The New Sydney Fish Market Stage 2 – Modification 11

State Significant Development Modification Assessment Report (SSD-8925-Mod-11)

October 2023

Figure 2 | Approved (top) and proposed (bottom) drop-off and pick-up zones (Source: Applicant's modification application)

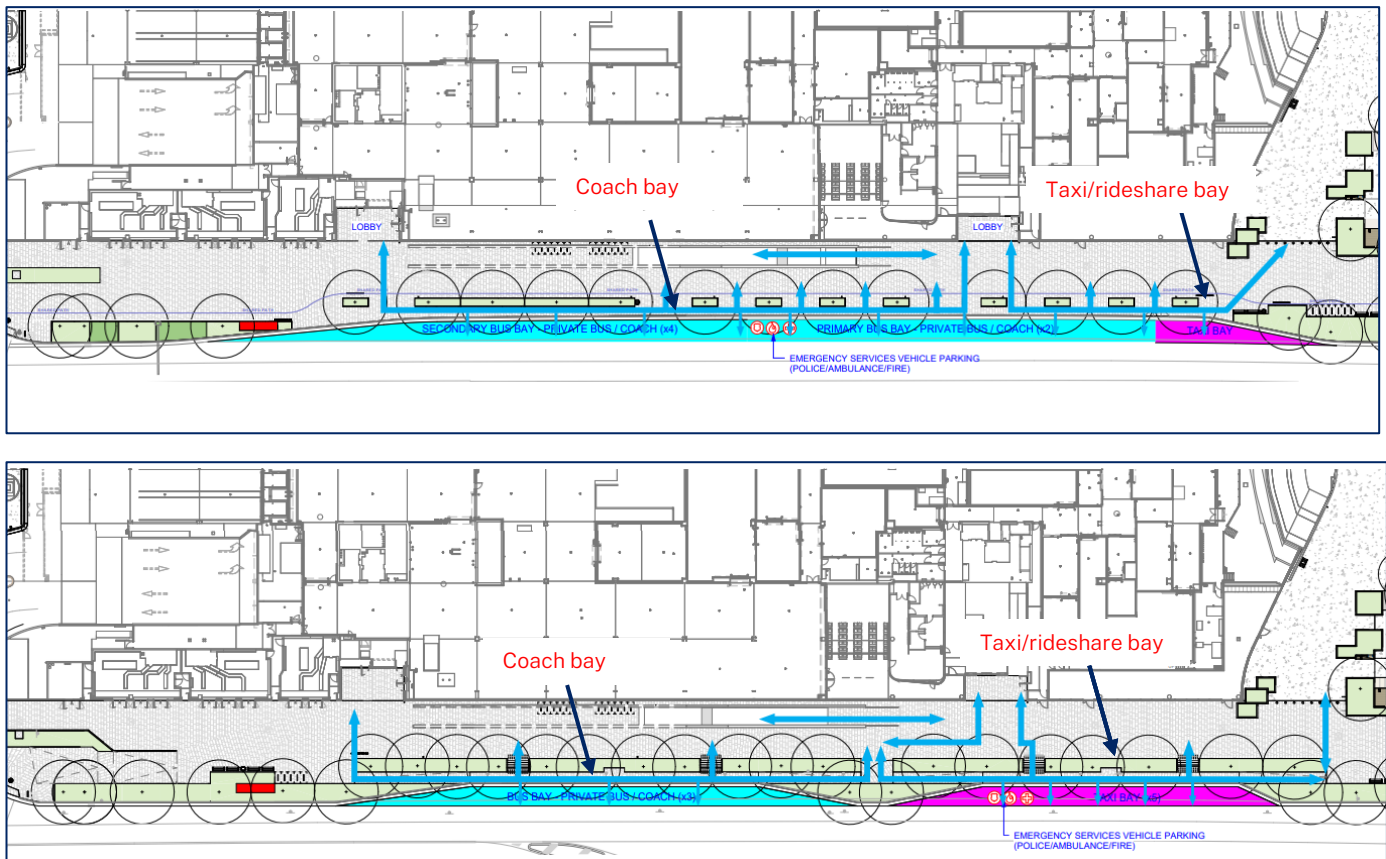
The modification application seeks to redesign the approved pick-up and drop-off lane on Bridge Road to separate the bays allocated to buses and taxi/rideshare services (**Figure 2**).

A public submission requested clarification on the potential increase in taxi/rideshare and bus movements under the modified design and whether there would be an associated impact to the performance of the Wentworth Park Road and Bridge Road intersection.

The Traffic Impact Statement submitted with the application confirmed dividing the approved bay into separate laybys would support wayfinding and safe vehicle movements, and achieve the necessary capacity for coaches and taxis/rideshare services. An RSA referenced in the Traffic Impact Statement recommended a crossing threshold be included in the pavement design for the shared path to warn cyclists and pedestrians of potential conflicts, and that landscaping not obscure sightlines from the drop-off and pick-up zone. A further Audit will be undertaken at the detailed construction drawing stage.

The Department considers the amended design acceptable as it supports safer vehicle movements, clearer wayfinding, and can accommodate the forecast demand created by the new SFM. The Department considers that because there has been no change to the approved gross floor area, parking spaces, or building extent, the modification will not increase visitor numbers.

Figure 4 | Approved (top) and proposed (bottom) Bridge Road frontage, as viewed from Bridge Road looking south (Source: Applicant's approved and proposed civil plans)

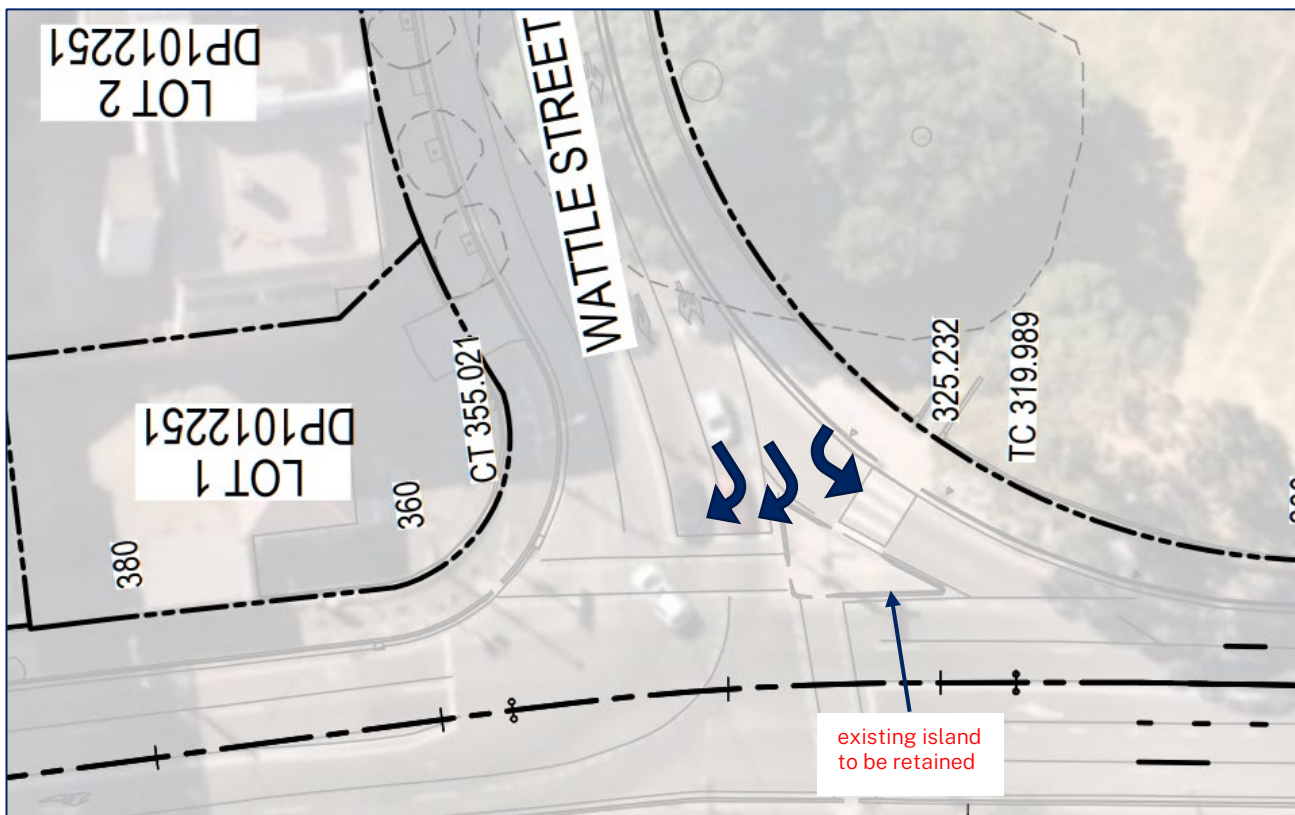
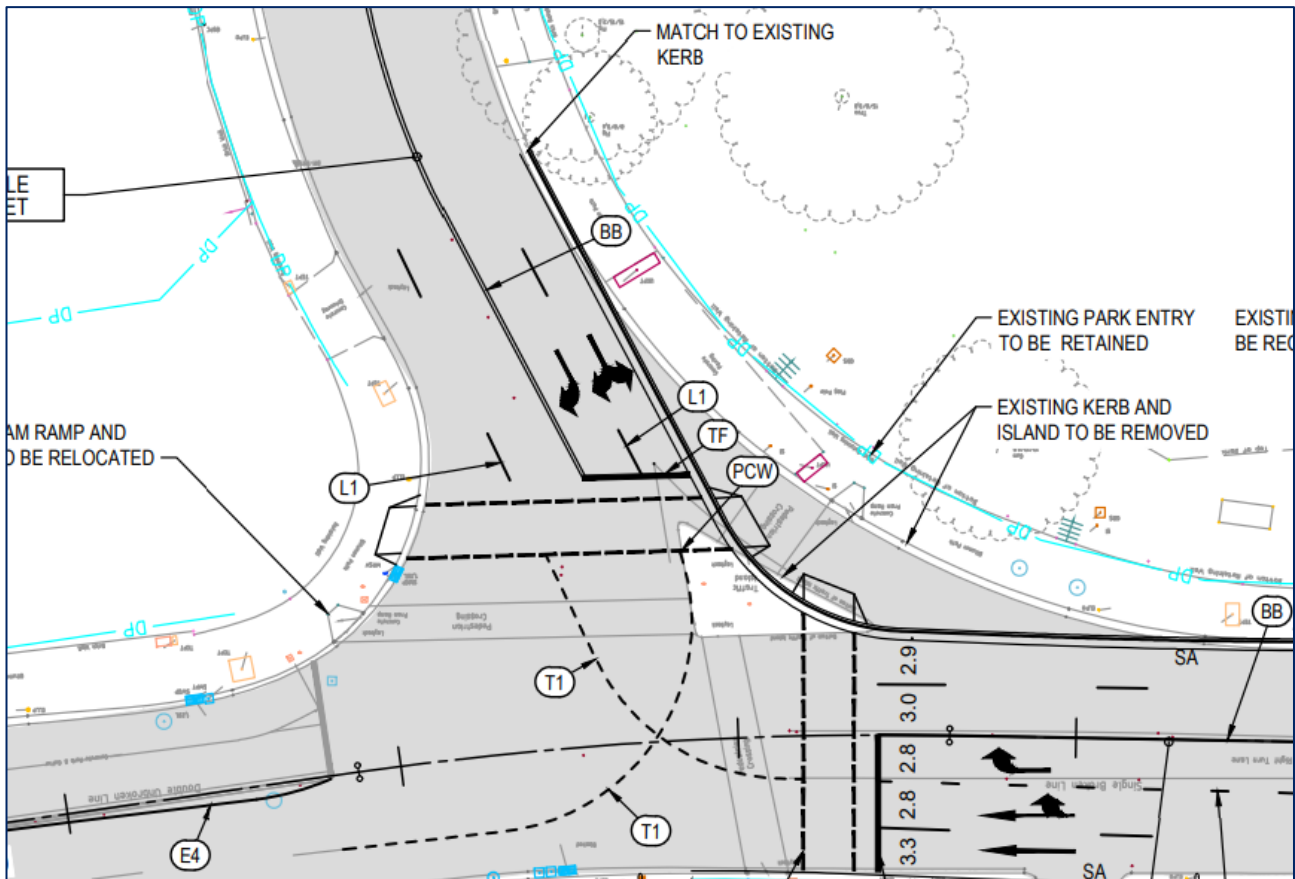
The modification application seeks to retain the existing intersection at Wattle Street and Bridge Road, including the existing slip lane for vehicles turning left onto Bridge Road, instead of proceeding with the amended intersection design approved under the SSD application (**Figure 4**).

Council raised concern that retaining the existing slip lane would create poor outcomes for walking and cycling by enabling traffic to turn at high speeds onto Bridge Road. Council also identified that the intersection design did not respond to the access arrangements proposed in the Blackwattle Bay Structure Plan.

The Department considers the proposed intersection design acceptable as it can facilitate pedestrian and cycle movements at a comparable LOS (of C to D) and accommodate the forecast demand. The Department notes TfNSW raised no concern with the operation of the intersection and would continue to resolve the detailed design as part of the existing Works Authorisation Deed and Condition B31 of the consent. The Department also supports reducing the construction impacts and specifically out-of-hours works through retaining the existing intersection design, as discussed further in **Section 5.1**.

The Department recommends a new condition (Condition B31A) that the detailed design plans for the intersection be subject to a Road Safety Audit (RSA) undertaken by an accredited road safety auditor, in accordance with the recommendations of the Applicant's Traffic Impact Statement that an RSA will be undertaken for the new design for Bridge Road and interface areas.

Figure 7 | Proposed changes to the Bridge Road levels (Source: Applicant's modification application)

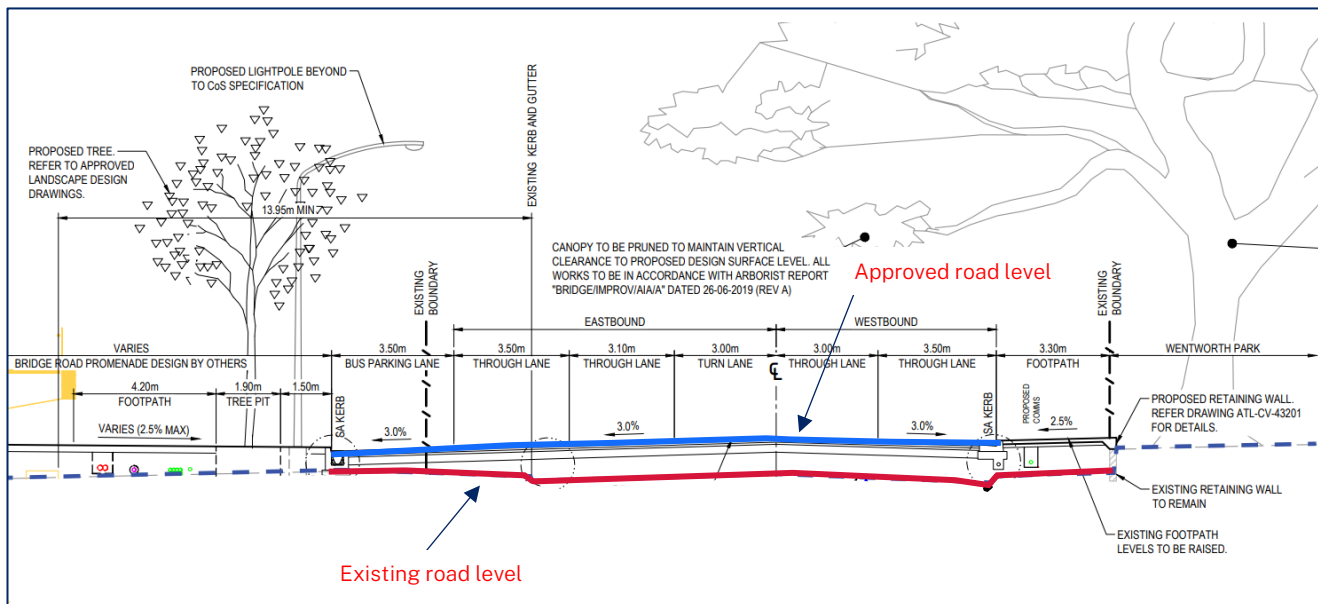
Council requested that the road design plan including stormwater, pavement, signage, line-marking and utility plan be approved by TfNSW, and noted no changes were required to the existing conditions of consent in this respect. Council also requested that the median along Bridge Road be painted rather than constructed in concrete to allow future flexibility.

A public submission raised concern that the modified road levels would change the profile of the access/egress driveway for the new SFM.

The Applicant's RtS confirmed the median is a painted chevron island, providing flexibility to amend the road layout in the future. The Department also notes that detailed plans will be submitted to TfNSW under Condition B31 of the consent.

The RtS also confirmed that the driveway entrance had been lowered by approximately 400 mm, amending the grade of the access ramp from 4.9% to 6.5%. The adjusted grade complies with the relevant Australian Standards and a vertical swept path assessment submitted with the RtS confirms the longest vehicle accessing the site will not scrape on the ground.

Figure 8 | Approved (top) and proposed (bottom) peak flood depth during the PMF event (Source: Applicant's modification application)

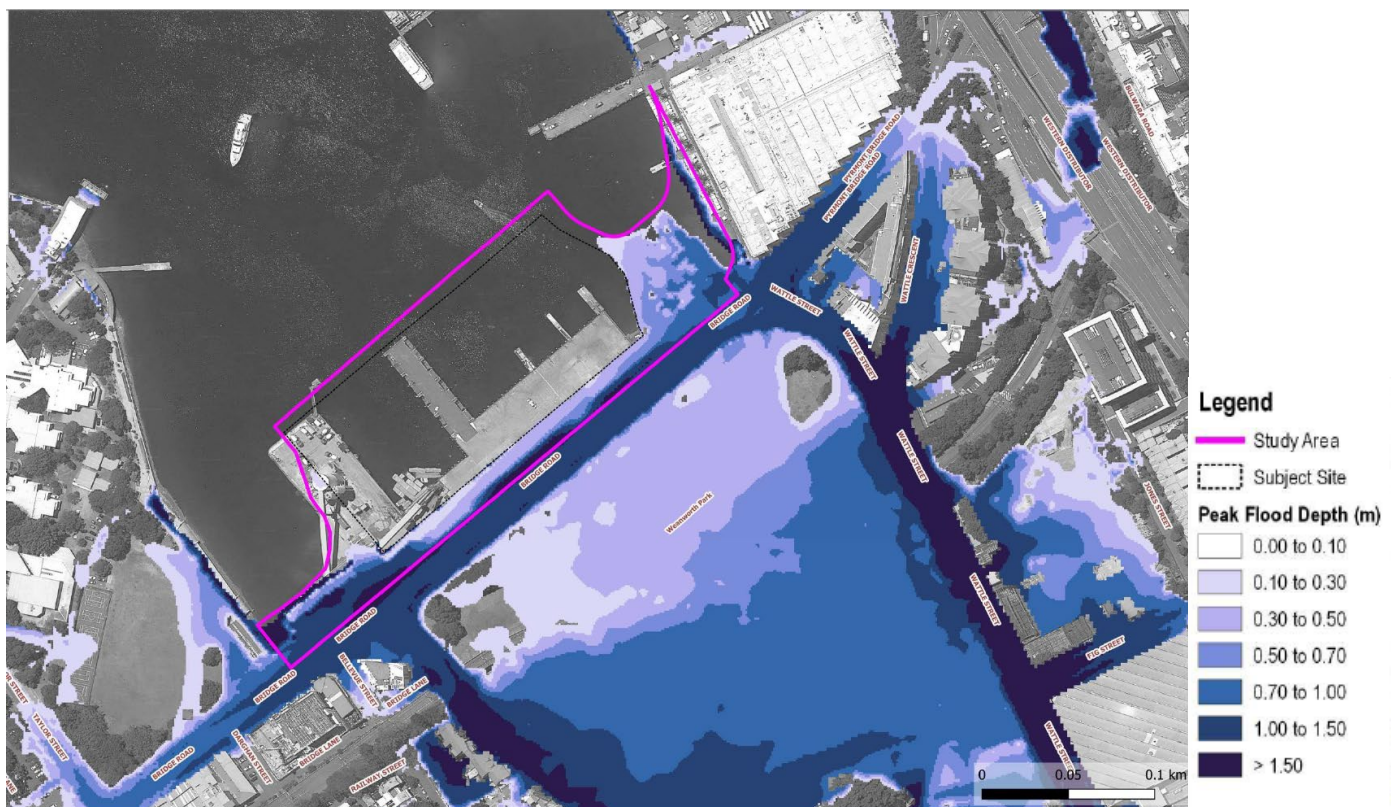
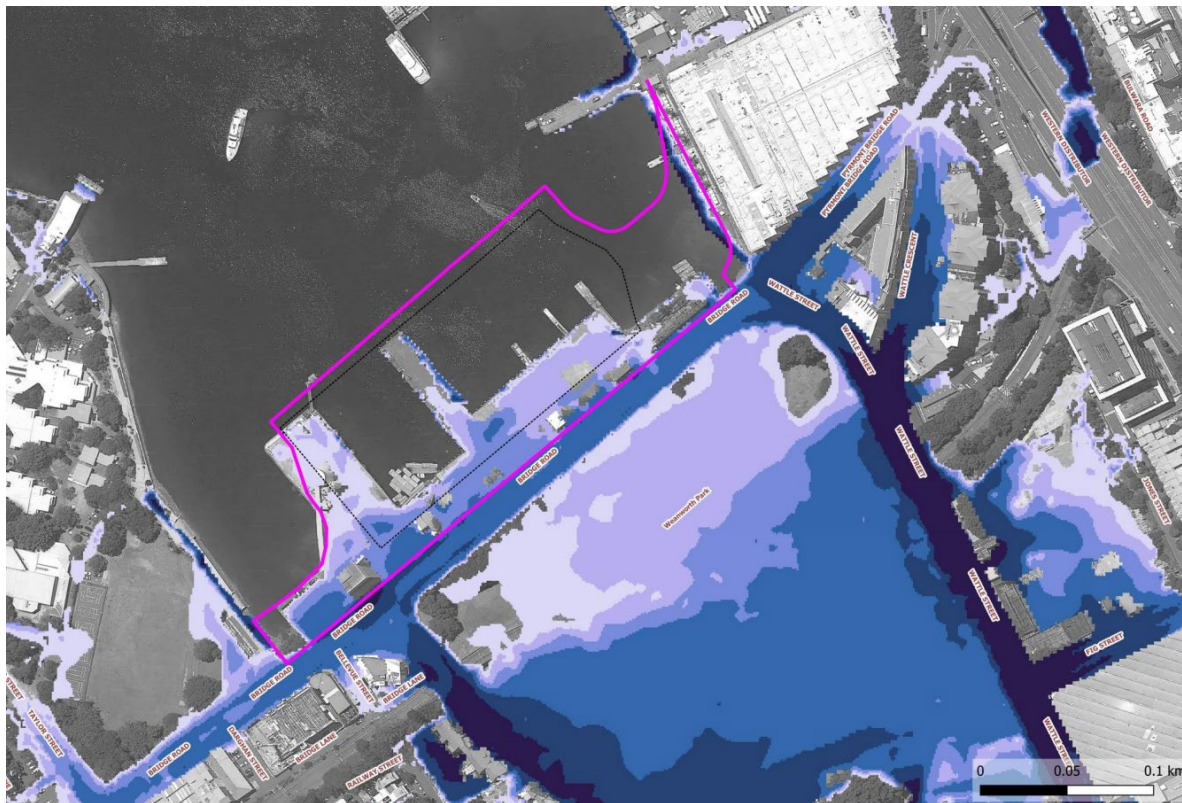
Council requested that the modified development continue to comply with the flood planning levels detailed in Condition B86 of the consent, and that the assessment be updated to reference the Flood Risk Management Manual which replaced the Floodplain Development Manual (2005).

The Applicant submitted an updated Flood Advice letter referencing the Flood Risk Management Manual 2023, reconfirming there are negligible flood level impacts outside of the subject site for the revised design, and demonstrating the development would comply with the flood planning levels for a PMF event (**Figure 8**).

Council did not raise concern with the findings of the updated letter and agreed that the flood planning levels referenced in Condition B86 of the consent should be updated.
